## *Claim Rejections-35 USC § 112*

## *Claim Rejections - 35 USC § 102*

#### *Response to Arguments*

**Figure 2: Effects of Deshpande's key process step on GaAs (left) and Silicon (right)**

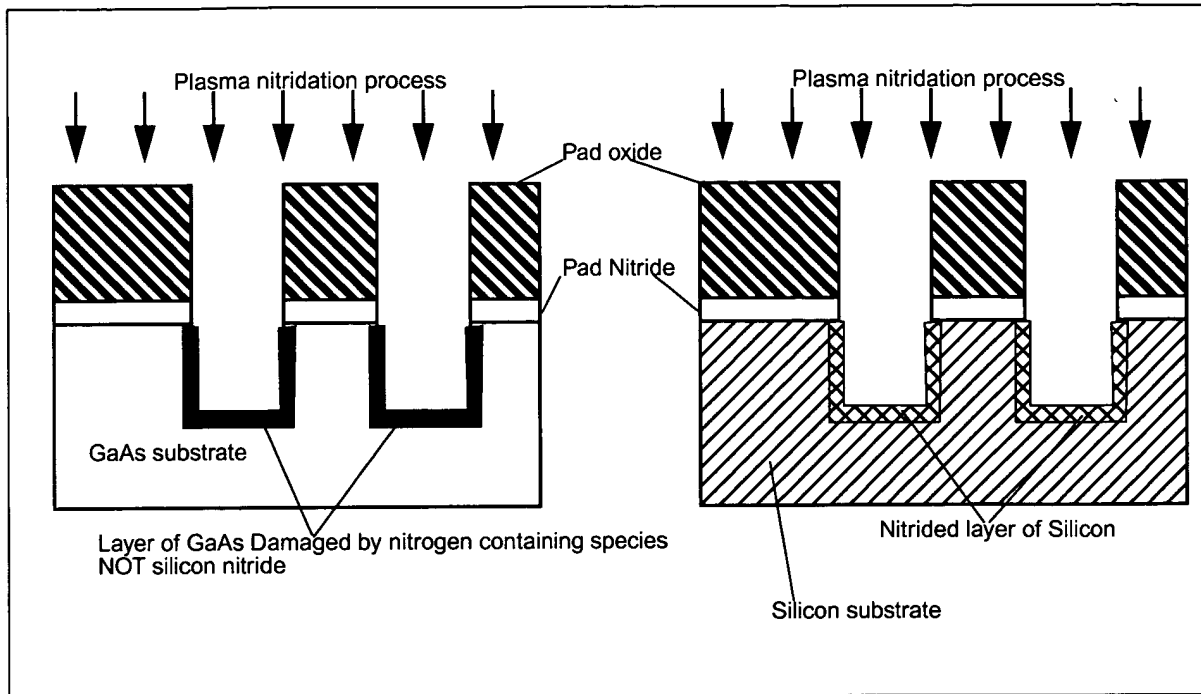
- Deshpande's Fig. 3D is mostly replicated on the right side of Figure 2 below, One

change made in this figure was to correct the placement of the nitrided layer, since  $N_2$ ,  $NO$ ,  $N_2O$ , and  $NH_3$  (Deshpande's claims 7,8,11,12,13,) cannot leave a layer on the semiconductor themselves, nor when used in combination with an inert gas (Deshpande's claims 9, 10, 14). So nitridation species must be acting in combination with the semiconductor substrate. Thus most or all of the effect of the nitridation step must be below the semiconductor surface.

**Figure 3: Structure views of Deshpande's process after planarization step on a GaAs wafer (left) and Silicon wafer (right)**

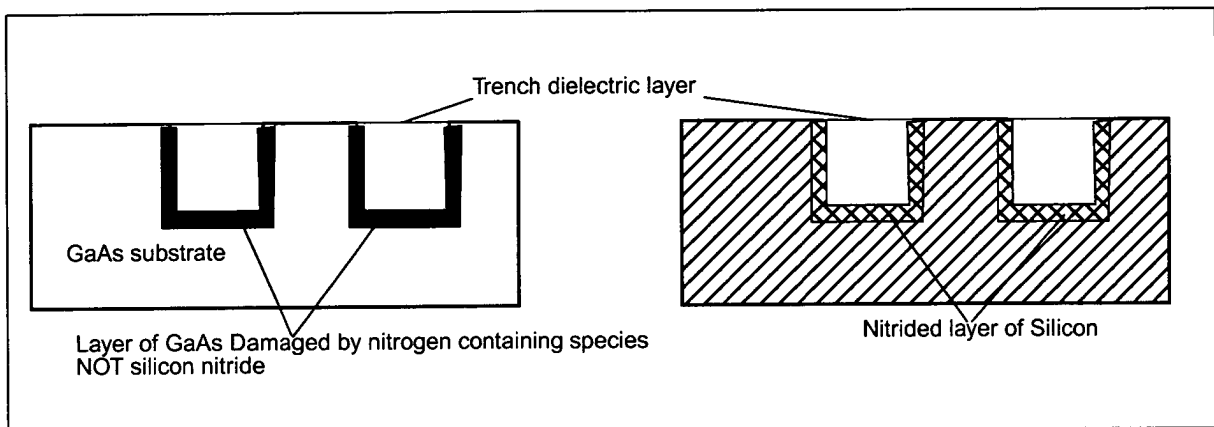
- The next step, illustrated by Deshpande's Fig. 3E, is mostly replicated by figure 3 below. While this is the next logical step in the case for the silicon wafer, this step pre-

cludes any chance for fixing the damage in the GaAs semiconductor.

- The purpose of the anneal cap on GaAs is to protect the GaAs crystal from damage during an anneal (high temperature) step. In some rare cases, an anneal cap may be avoided by using an arsenic over-pressure during anneal. By placing the trench dielectric layer immediately over the damaged semiconductor caused by the nitridation step, the surface will be forced to lose significant arsenic during anneal regardless of any overpressure used during an anneal step. This is true for any of the trench dielectric materials listed in Deshpande's detailed description: Conventional  $\text{SiO}_2$ , TEOS oxide, and HDP oxide.

**Figure 4: Comparing GaAs wafer (left) to silicon wafer (right) after thermal oxidation step**

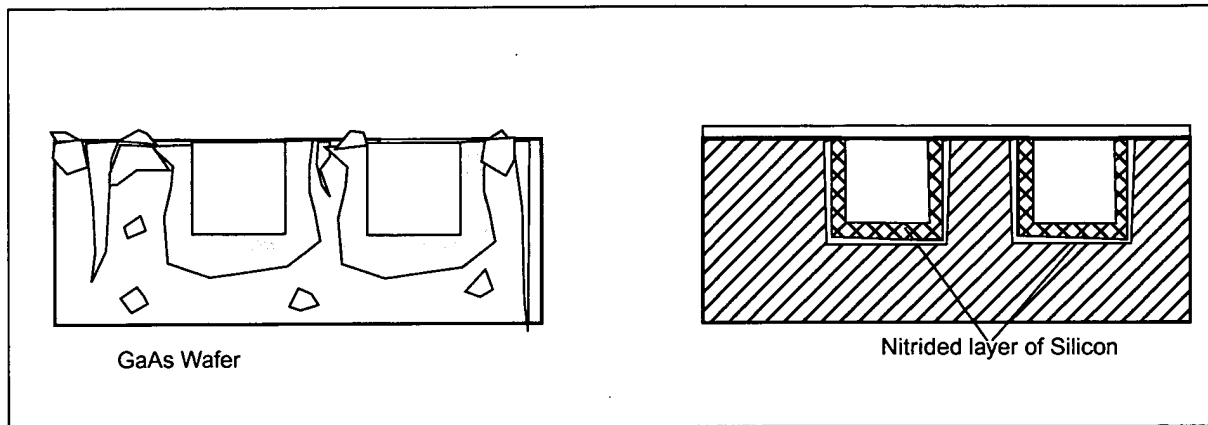
- Even if the nitridation step were skipped, and the GaAs was not damaged yet, the inclusion of this oxide deposition step will result in the semiconductor being damaged. Since silicon oxide compounds do not act as stoichiometry preserving anneal caps, their direct interface with semiconductor cannot be considered compatible with GaAs.
- Deshpande's claims 1 and 21 imply the proceeding steps are to be followed by conventional CMOS processing using thermal oxidation. This is confirmed in the Background of the invention, the summary of the invention, and detailed description sections of the application. Figure 4 below shows the effect of the necessary thermal

oxidation steps on both the III-V semiconductor structure and the silicon based structure.

- On the silicon wafer, the nitrided layer of silicon effectively reduces the amount of silicon that gets oxidized below it. This reduces the resulting stress on the edge of the isolation structure. The attempted thermal oxidation of the GaAs wafer is a disaster. The high temperature used in the thermal oxidation step in combination with the oxygen-containing ambient not only forms unstable gallium and arsenic oxides, but also allows significant arsenic to escape from the wafer, coating the inside of the equipment used for the process step. Such significant loss of arsenic breaks-down the crystal in such a way that large pits are left in the semiconductor surface.

- Thus a conventional CMOS process is incompatible with GaAs wafers, so an invention that reduces the amount of oxidation along the edge of an isolation structure during a gate thermal oxidation does not apply to GaAs.
